4 January 2018

Reference No. 1791400-001-L-Rev0

PEER REVIEW OF AQUIFER PROTECTION STRATEGY FOR PROPOSED ICASA RESORT LIVING DEVELOPMENT IN SUMMERLAND BC

Figure 1: Hydrogeological cross-section through aquifer prepared by Piteau

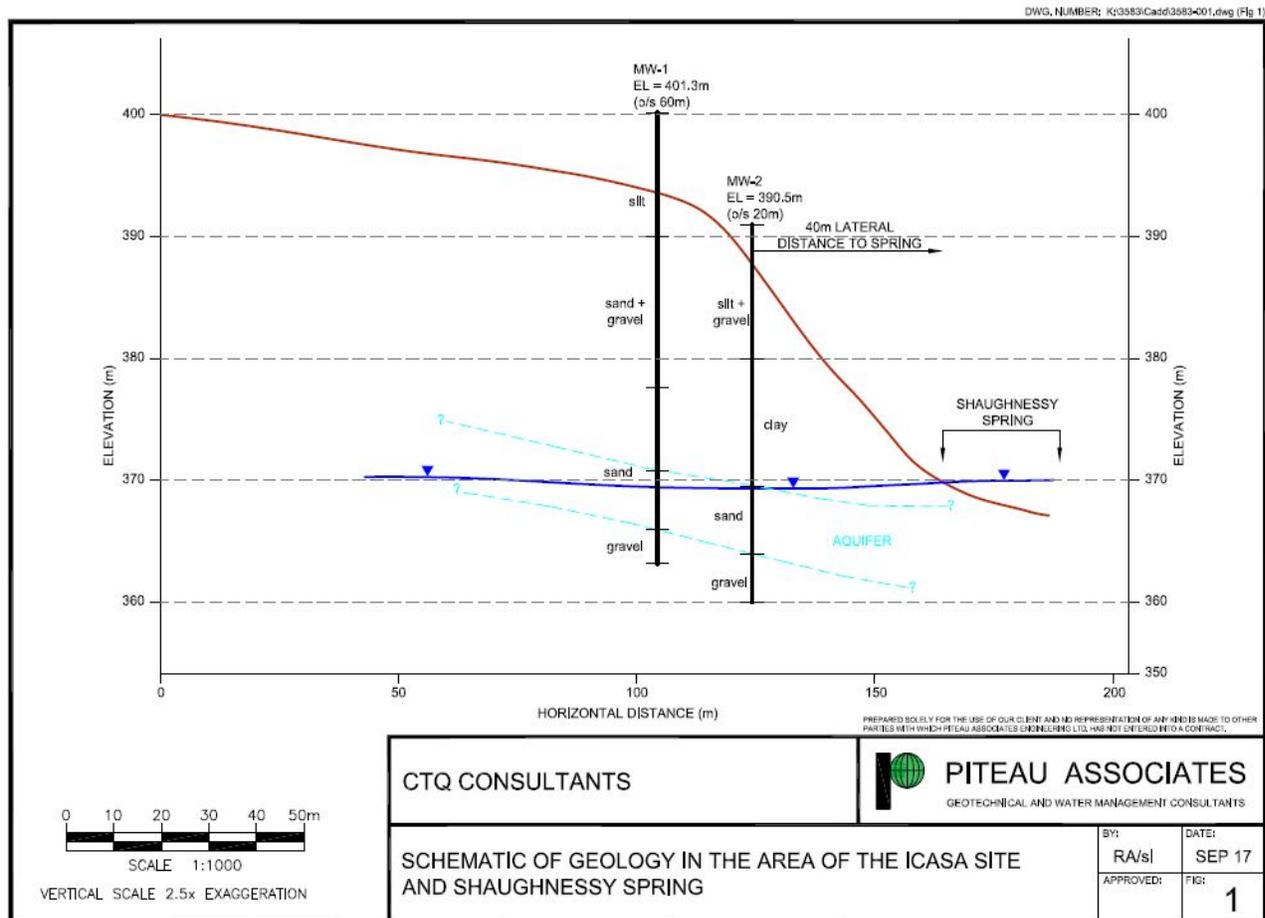
The groundwater table beneath the site is understood to have been close to the groundwater elevation at Shaughnessy Springs (about 370 masl - Figure 1) when measured in the monitoring wells. The groundwater level reported on the MW-3 field log was about 20 m below surface. The field log reports heaving (saturated and under upward hydraulic pressure) silt and sand from 20 to 27 m below grade underlain by a stable sand and gravel unit that was assessed (by Golder) to be the aquifer.
